**AGENDA**  
**CITY OF LAKE WORTH BEACH**  
**HISTORIC RESOURCES PRESERVATION BOARD MEETING**  
**CITY HALL COMMISSION CHAMBER**  
**WEDNESDAY, FEBRUARY 11, 2026 -- 6:00 PM**

### **HRPB 26-01500001 - 338 Cornell Dr**

## HISTORIC RESOURCES PRESERVATION BOARD REPORT

**HRPB Project Number 26-01500001:** A request for a variance to allow an 8-foot-high fence along the side alley property line at 338 Cornell Drive. The subject property is a contributing resource within the College Park Historic District and is located in the Single Family Residential (SFR) zoning district. The future land use designation is the Single Family Residential (SFR).

Subject fencing at 338 Cornell Drive, 8 feet tall (marked in orange)

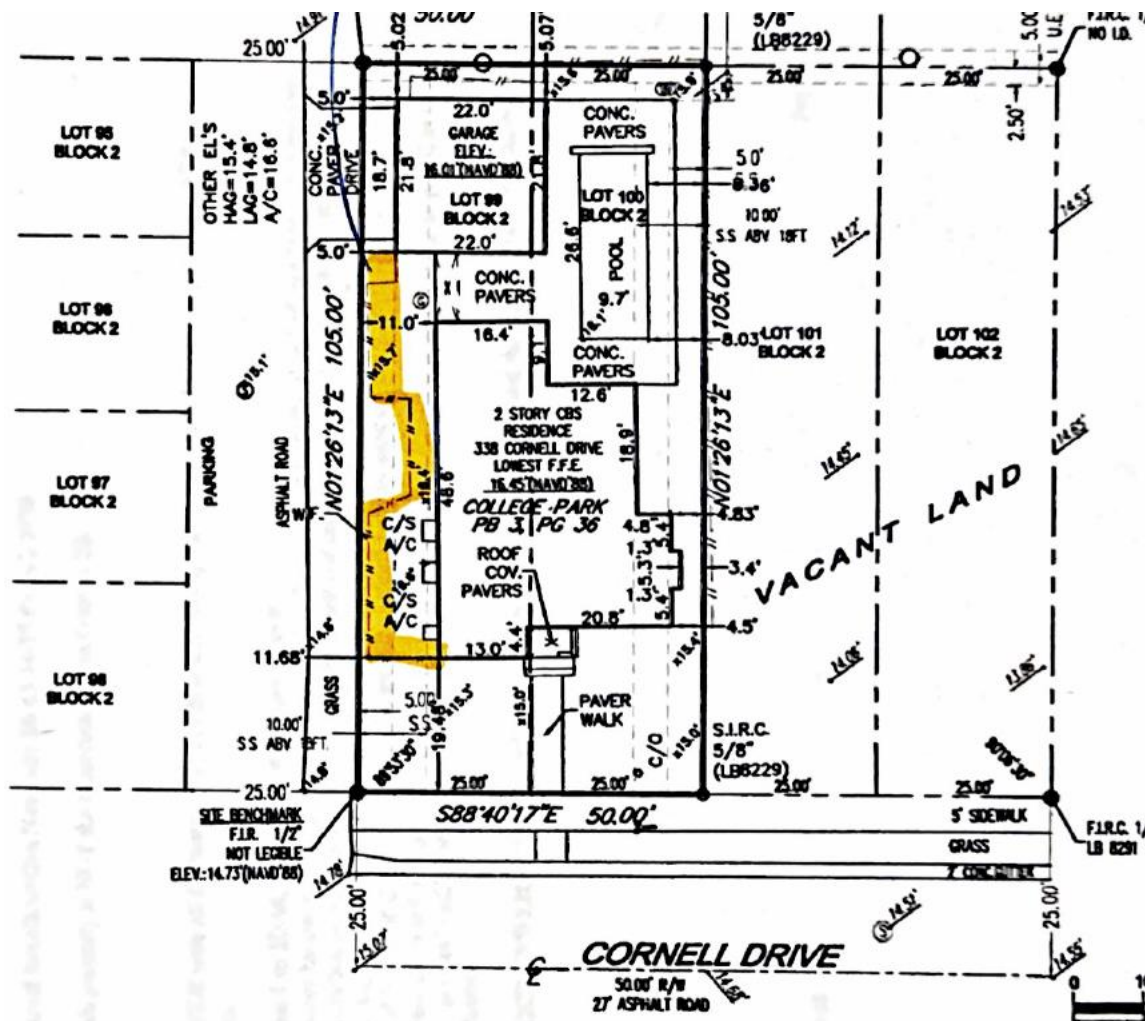
**Analysis:** The fencing on the west side property line at 338 Cornell Drive conflicts with the requirements in the City's Land Development Regulations, specifically the limitations for maximum fence height alongside property lines.

Per LDR Section 23.4-4(d)(1)(C), the maximum height of fences or walls on the side property line is six (6) feet. While 8' fencing is permitted along alleyways, the code specifies that this applies only to rear property lines. The applicants are proposing approximately 80.5 linear feet of fencing on the west side property line along an alley that measures 8' in height (see survey image below).

Required by Code	Proposed
LDR Section 23.4-4(d)(1)(C): On the rear property line (not adjacent to an alley) and on that portion of the side property line from the rear property line to the front building setback line, a fence or wall shall have a maximum height of six (6) feet from the natural grade of the lot.	Approximately 80.5 linear feet of fencing along the west side property line, with a height of 8 feet

Variance requests are required to be reviewed for consistency with the criteria set forth in LDR Section 23.2-26(b), including the requirement that a hardship be established related to the circumstances of the property. As the circumstances of the subject lot are generally typical, evidence for a unique hardship cannot be established. Further, the applicant has not established competent and substantial evidence that the proposed variance is consistent with the required review criteria, including that the strict application of the LDRs would deprive the property owner of any reasonable use of the land. Therefore, staff is recommending that the HRPB not approve the proposed variance based on the data and analysis in this report.
